RFI#: 0575

Subject: Grading at Deck A East Entrance @ Loading Dock
Project: THE DOMAIN - Phase I
Address: 11400-A Burnet Road
Austin TX 78758 US
Phone: \$12-873-2900
Phone: \$12-873-2900
Fax: \$12-873-2925
To: Judy Raymond
J Robert Anderson Landscape Architects
From: HCBeck, LTD
Contact: John Duke
Co-Author:
Co-Author:
Contact:

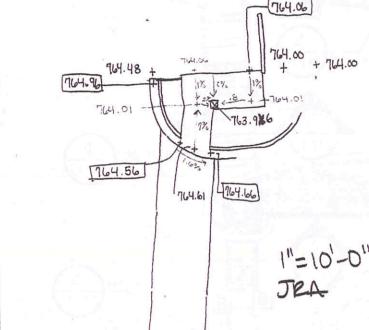
Request
Refer to the attached sketches / blow ups of the area east of Deck A at the middle entrance.
The finish elevations for the hardscape grading plans and the Deck drawings do not match. See the handsketch for as-built elevations in the area. This area does not appear to need steps and handralis. Please advise.

Answer | Accept Suggestion in the area and the Deck drawings are consistent elevation across the building of 764.06. We also assume there is no inappropriate step inside the building as this RFI states that the outside elevation is 1.06' higher than the drawing's stated FFE of 763.00.
